PROJECT: Jensen S. Helena Area 4

CITY OF LAS VEGAS		DATE:
INTER-OFFICE MEMORANDUM		March 28, 2019
TO: Land Development Services Department of Building & Safety		FROM: Jennifer Shinn, P.E.  Flood Control, Engr. Associate Department of Public Works
SUBJECT:	Drainage Study for:	COPIES TO:
	Jensen & Helena Area 4	Taney Engineering
Cross Streets:	SWC of Helena Ave and Grand Canyon Dr	Lone Mountain Estates, LLC
File Number:	F:\Depot\DSMemos\DS5076A.doc	Bart Anderson, P.E., DevCo
Parcel Number:	138-06-301-013	CCPW
Zoning Action:	TMP-74627	
FEMA Flood Zone	YES	NO X
Proposed Storm Drain	YES	NO X

SUPPLEMENT #1

Jensen & Helena Area 4
Residential Development

48-INCH RCP STORM DRAIN (PUBLIC) - PLAN
STA: 0+00.00 TO 2+37.00

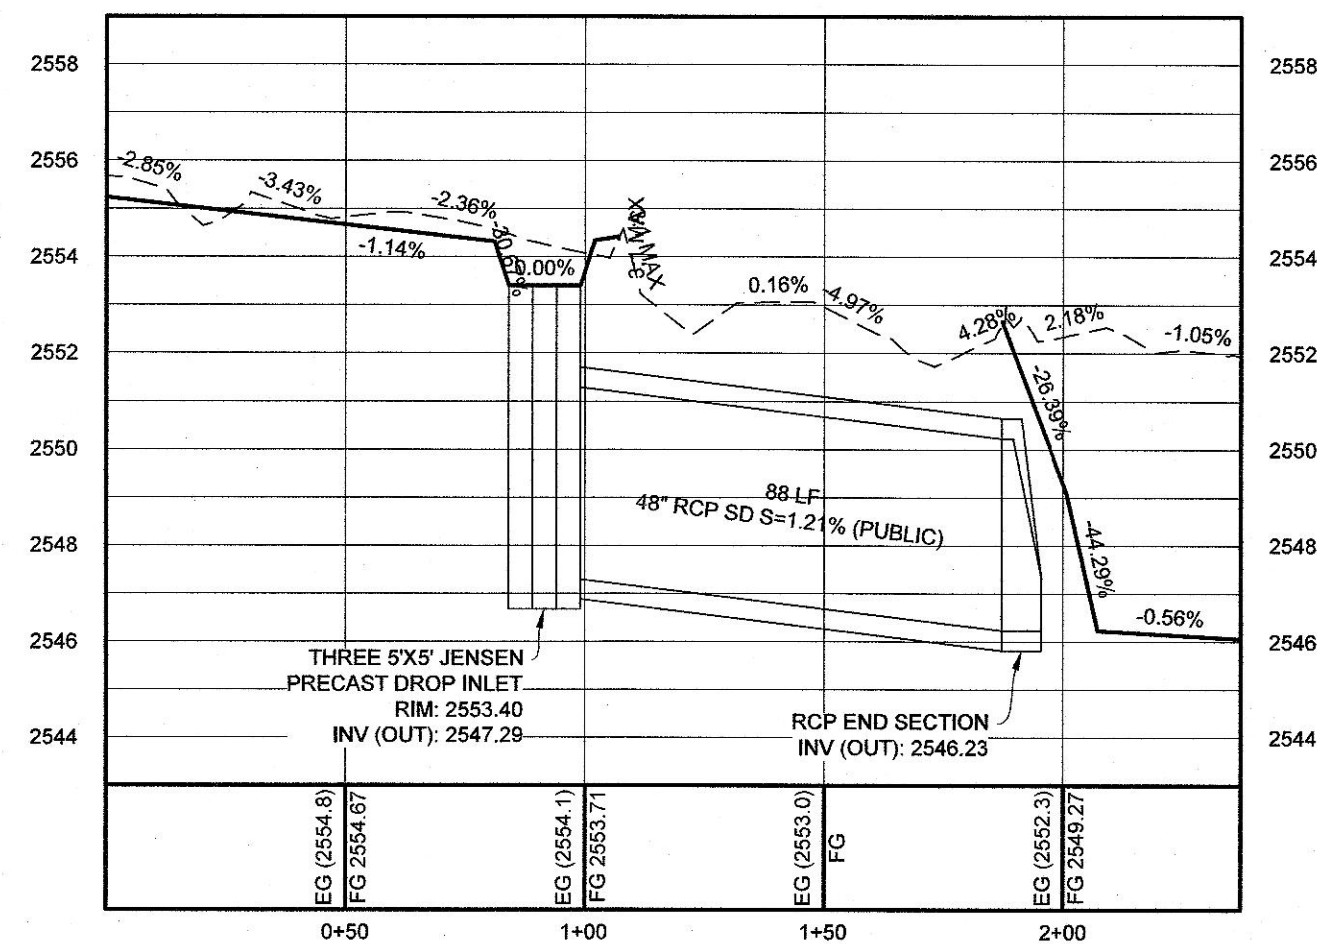
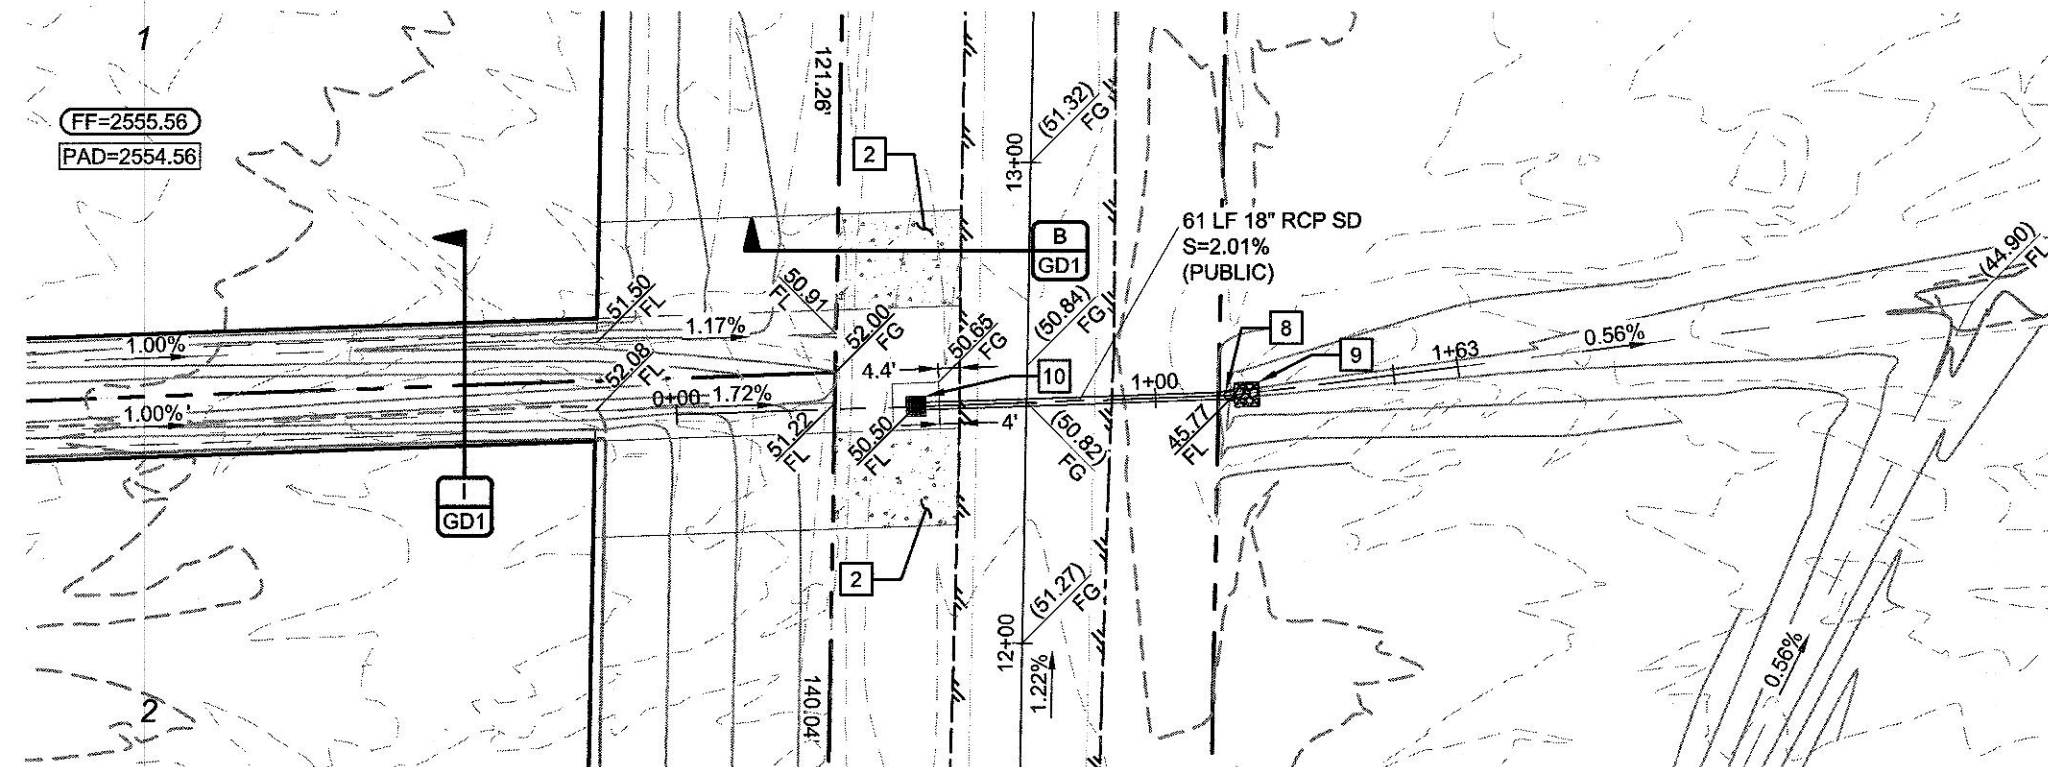
Comment 5: Revise FlowMaster worksheet for 48" RCP to match pipe slope shown on profile sheet.

The pipe slope that is shown on the plan and profile sheet is 1.21%. This slope has been added to the FlowMaster calculation for the 48" RCP and may be found in Appendix B.

Worksheet for E - 20' Drainage Easement

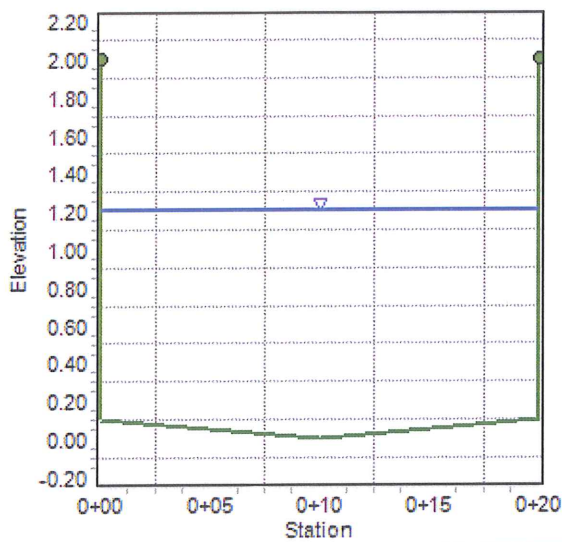
4. Revise the note on Detail A to call out "20' Public Drainage Easement to be Privately Maintained by HOA".

NOTE THAT THE EASEMENT HAS BEEN WIDENED TO 20' DUE TO PONDING ISSUES THAT WERE OCCURRING AT THE ENTRANCE OF JENSEN.
